# UNITED STATES PATENT AND TRADEMARK OFFICE

APPLICATION NO.	FILING DATE	FIRST NAMED INVENTOR	ATTORNEY DOCKET NO.	CONFIRMATION NO.
10/068,230	02/04/2002	John T. Vaughey	215	7626

**Office Action Summary**

**FIGURE 1**

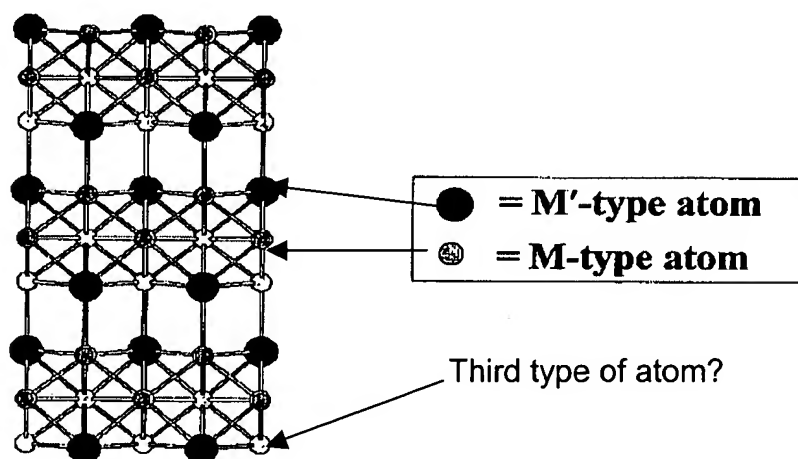
The drawings are objected to under 37 CFR 1.83(a) because they fail to show the structure of  $\text{Cu}_2\text{Sb}$  as described in the specification. Any structural detail that is essential for a proper understanding of the disclosed invention should be shown in the drawing. MPEP § 608.02(d). Applicants' illustration of a  $\text{Cu}_2\text{Sb}$  type structure in Figure 1 fails to provide details essential for a proper understanding of applicants' invention because only a two-dimensional view of the three dimensional structure is given, and the illustration appears to show three different types of atoms but identifies only two types, namely M' and M.

A proposed drawing correction or corrected drawings are required in reply to the Office action to avoid abandonment of the application. The objection to the drawings will not be held in abeyance.
